SUBJECT: Forwards response to listed question re topical rept  
           DPC-NE-3003, "Mass & Energy Release & Containment Response  
           Methodology."

Subject: Oconee Nuclear Station  
Docket Numbers 50-269, -270, and 287  
Topical Report DPC-NE-3003, "Mass and Energy Release and  
Containment Response Methodology"; Response to RAI

## OCONEE MSLB/EQ ANALYSIS

***VIKING LOCA Test Vs. MSLB Vapor Temp***

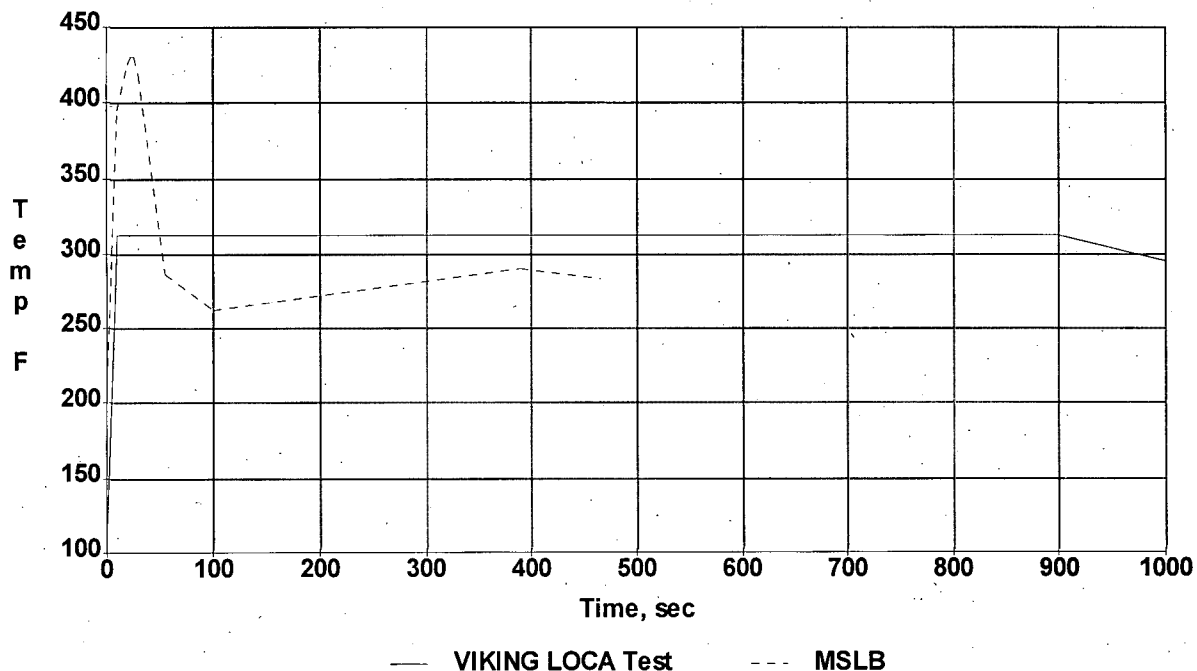
In a telephone call on June 1, 1994 between Len Wiens of the NRC and Scott Gewehr of Duke, regarding the subject topical report, a question was put forth regarding main steam line break temperature and equipment qualification in containment. Attached please find Duke's response to this question.

The Viking penetration was tested at a peak temperature of 312°F for the first 15 minutes, ramped down to 295°F for the next 45 minutes, and then held at 290°F for a further 23 hours. The Viking profile compared to the LOOP180 MSLB is shown below:

Additionally, the Viking penetration was thermally aged and irradiated prior to LOCA testing. The component parts were thermally aged to well over 60 years using Arrhenius methodology and irradiated to postulated LOCA doses ( $>10^8$  rads) which are not present during a MSLB.
